SAFETY EVALUATION BY THE OFFICE OF NUCLEAR REACTOR REGULATION

SOUTH TEXAS PROJECT, UNITS 1 AND 2

GRADED QUALITY ASSURANCE PROGRAM

DOCKETS NOS. 50-498 & 50-499

Figure 1
Probabilistic Risk Importance Thresholds for Input to
GQA Component Classifications

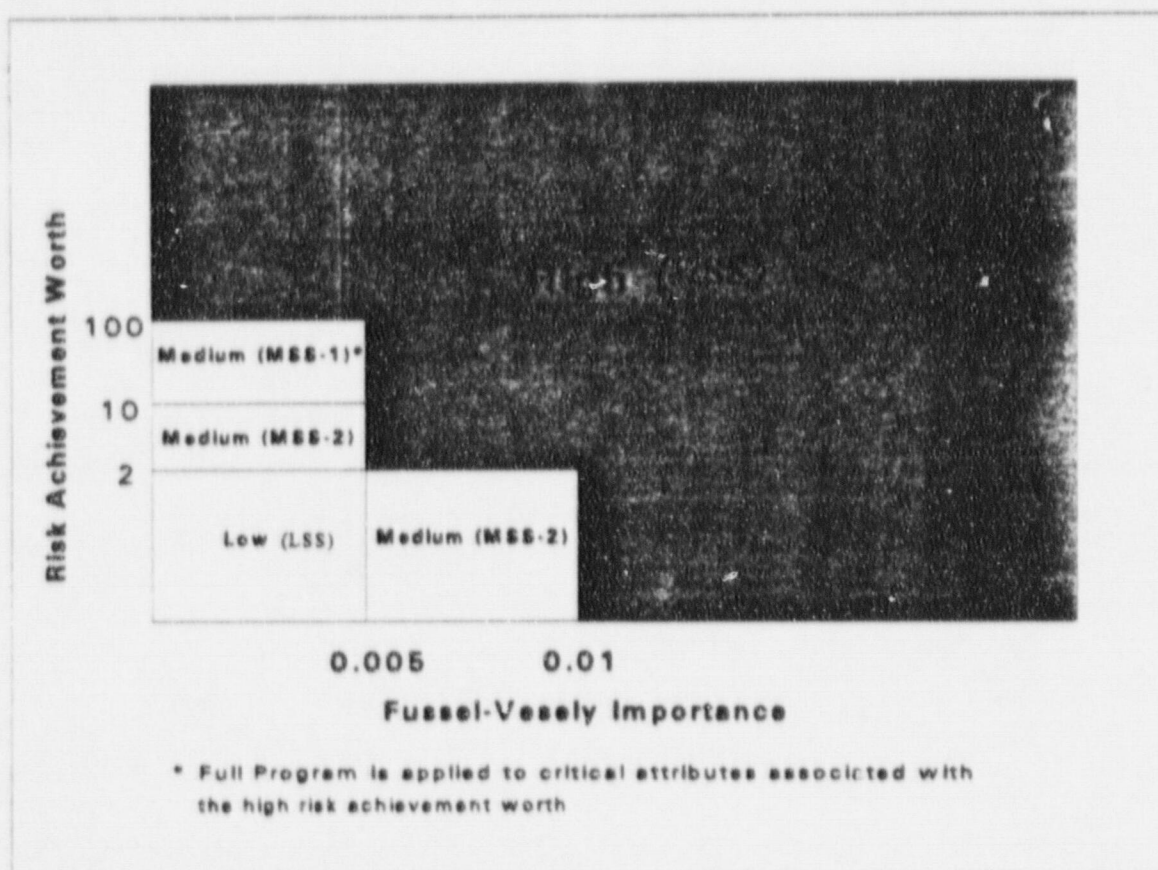
Figure 1 graphically illustrates the relationship between the RAW, FV, and the safety-significance categories for those SSCs modeled in the PRA. Since FV and RAW are relative measures, both CDF- and LERF-related results are compared to the guidelines and the SSC assigned the highest category. The staff finds this process acceptable, and that the suggested RAW and FV values provide reasonable assurance that plant equipment will receive a level of QA control commensurate with importance to safety. Furthermore, since the licensee assigns all SSCs with elevated RAW to the HSS or MSS-1 categories, the staff finds that the licensee's proposal conforms with the Draft RG DG-1064 (Reference 3) position that high reliability alone is not sufficient for reducing QA controls.
